UNITED STATES PATENT AND TRADEMARK OFFICE

APPLICATION NO.	FILING DATE	FIRST NAMED INVENTOR	ATTORNEY DOCKET NO.	CONFIRMATION NO.
10/659,145	09/10/2003	Marie Ann McMasters	GE126465	3043
29827	7590	07/05/2005	EXAMINER	
FRANCIS L. CONTE, ESQ. 6 PURITAN AVENUE SWAMPSCOTT, MA 01907			KIM, TAE JUN	
			ART UNIT	PAPER NUMBER
			3746

Office Action Summary

FIG. 3

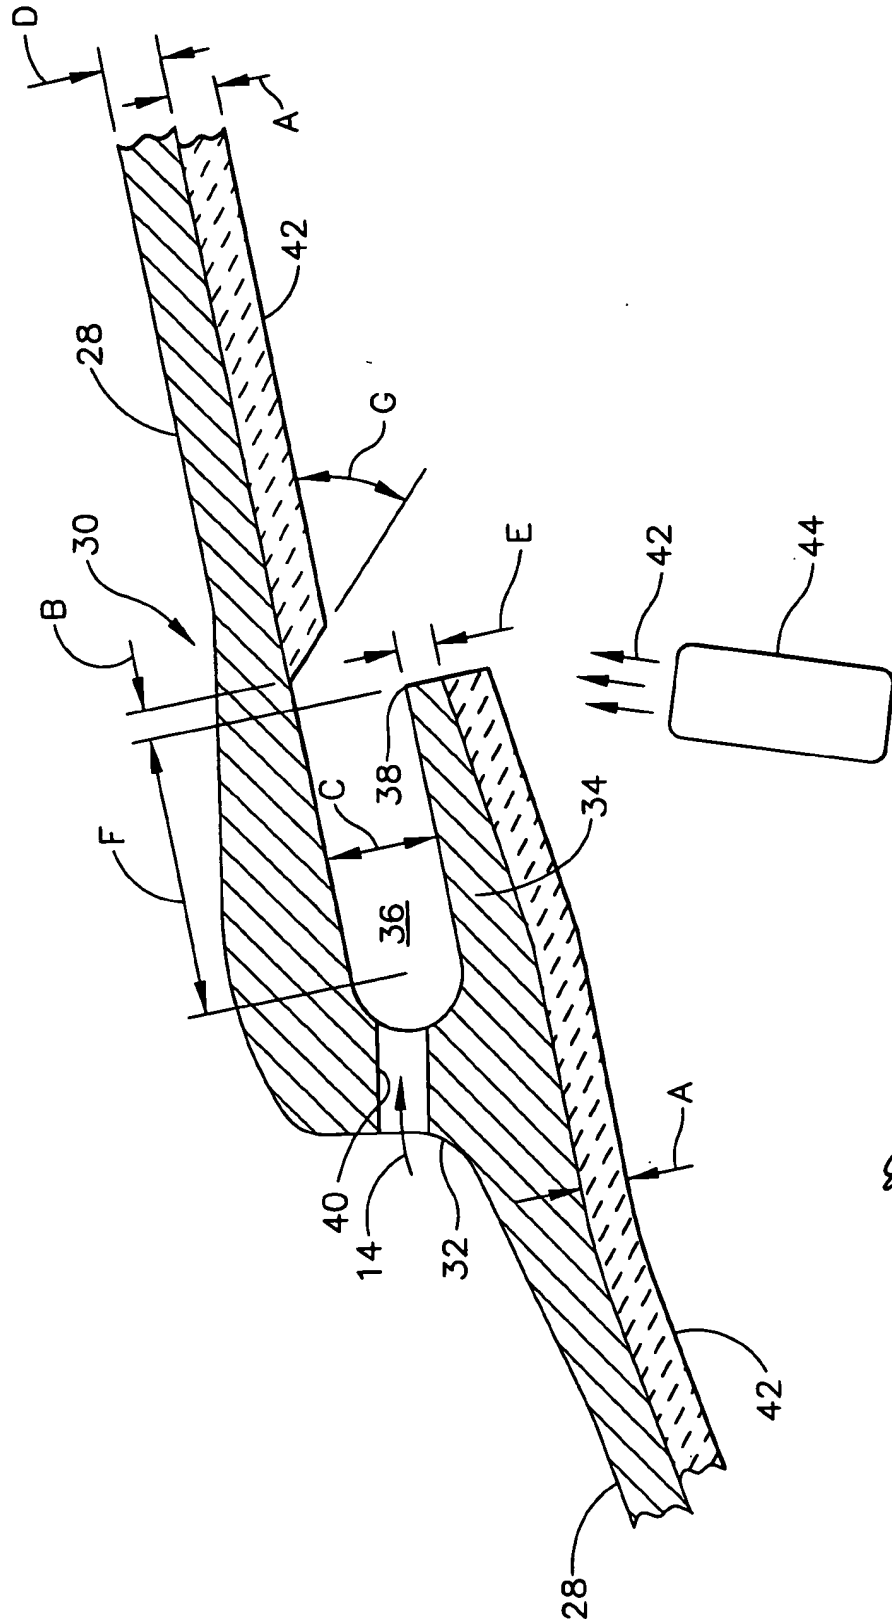
1. Claims 1-22 are rejected under 35 U.S.C. 112, first paragraph, as failing to comply with the written description requirement. The claim(s) contains subject matter which was not described in the specification in such a way as to reasonably convey to one skilled in the relevant art that the inventor(s), at the time the application was filed, had possession of the claimed invention. Applicant's amendment of the specification and drawings is inconsistent with those originally filed with the office. In the originally filed drawings in Figures 3 and 4, the "transverse" spacing B was shown diagonally to indicate the spacing between the lip and the coating aft of the slot. Originally filed Figure 4 shows the spacing H as an "axial spacing". Applicant's modification of the figures removes the original "B" from both Figures, replaces "H" in Figure 4 with "B", and uses an "axial spacing" B in both Figures 3 and 4. However, it is clear from the specification that spacing C was also "radial" or "transverse" and applicant cannot designate spacing B, which was originally designated as a "transverse spacing" in paragraphs 31-34 and yet with the amendment to paragraph 50 changes the designated spacing B to an "axial spacing." Applicant's amendment introduces new matter in redefining how the spacing B, which is the only spacing generic to both Figures 3 and 4, from that of the original specification and drawings.

Entry Not
 Approved
 Issue of
 new matter
 TM
 5/5/05
